DEPARTMENT OF ENVIRONMENTAL HEALTH
MECKLENBURG COUNTY, NORTH CAROLINA

SITE EVALUATION

S.I.R. NO. 21562

SUBJECT: Soil/Site Evaluation of G.M. Harwood Property on Harwood Lane

**See Diagram on Back (includes: soil areas, property lines, roads, streams, gullies, wet areas, fill areas, wells, water bodies, slopes)

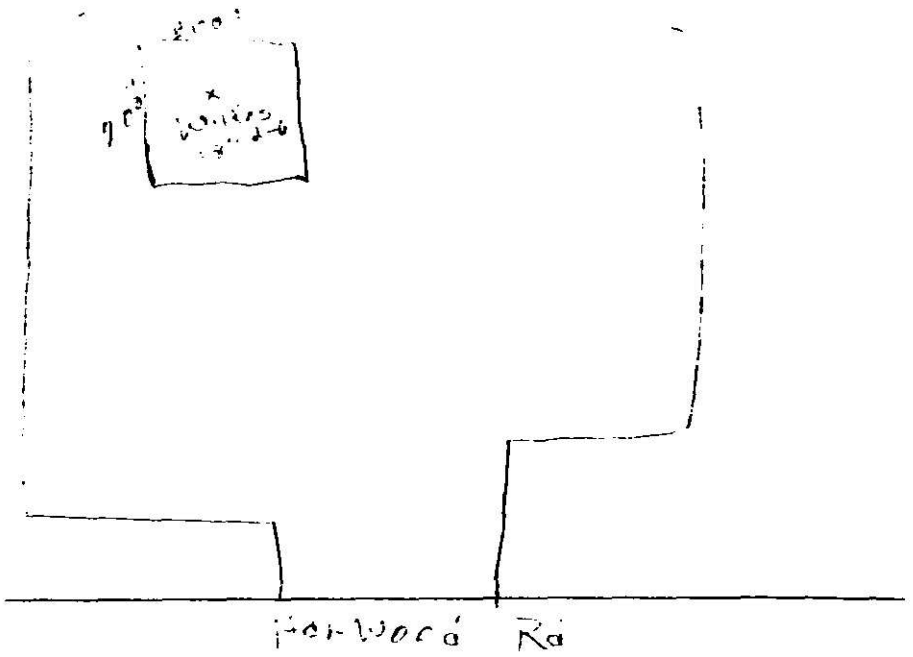
Recommendations/Comments: 6" H2O Table [illegible] Area shows 4 acres of [illegible] suitable for [illegible]
